Office Action Summary

10/522,205

DETAILED ACTION

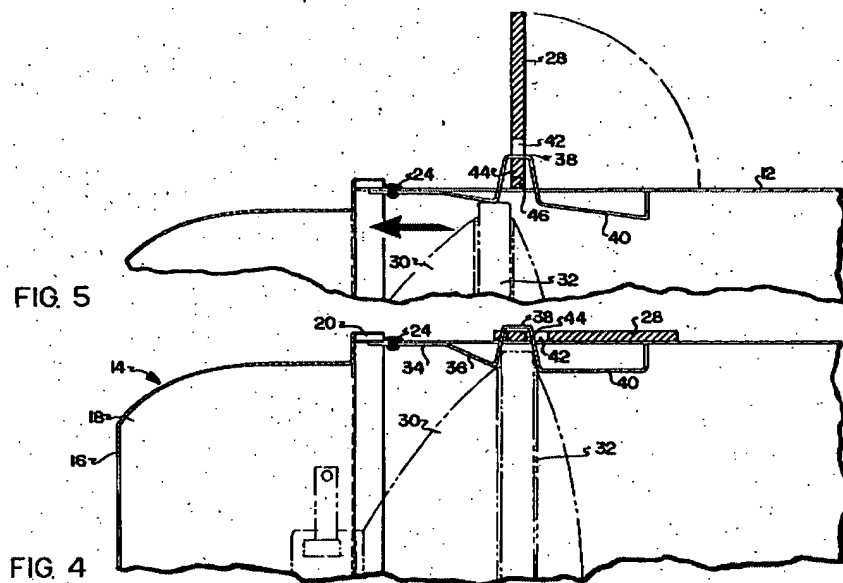
Claim 1. (currently amended): Fitting for a lamp (retainer, title), provided with a rim (rim of reflector, 32, Figs. 4 and 5) or stop for supporting a lamp cap (cover, 14), and a locking element (retainer portion, 38), such as a nut, for locking a lamp cap onto said rim or stop, the fitting being provided with adjustment means (spring members, 22) ~~(20,40)~~ for adjusting the position of the lamp cap with respect to said rim or stop (Column 2, lines 53-56, Figs. 4 and 5), characterized in that said adjustment means ~~comprise~~ comprising a first part (release cam bar, 28) ~~(21,41)~~, a first end of which is movably connected to said rim or stop, it being possible for the first part to be placed between a first position substantially parallel to the rim or stop and a second position at an angle to said rim or stop (Figs. 4 and 5).

Claim 2. (currently amended): Fitting as claimed in claim 1, ~~characterized in~~ wherein the adjustment means comprise a first (release cam bar, 28) and a second part (spring members, 22) ~~(22,42)~~, which parts are pivotally ~~(23,24)~~ connected to one another (Figs. 4 and 5), the second part being supported on the rim or stop and it being possible for the first part to be placed between a first position substantially parallel to the second part and a second position at an angle to the second part (Figs. 4 and 5).

Claim 12. (currently amended): Adjustment element as claimed in ~~claims 7-11,~~
~~characterized in that~~ claim 7, wherein the adjustment element comprises auxiliary
arms arranged between the first part and the second part, which support arms
absorb spring force during the displacement of the first part toward the second
part (Figs. 4 and 5).

Claim 13. (currently amended): Adjustment element as claimed in claim 12,
~~characterized in that~~ wherein the auxiliary arms are punched and flanged out of
one of the first and second parts (Figs. 4 and 5).
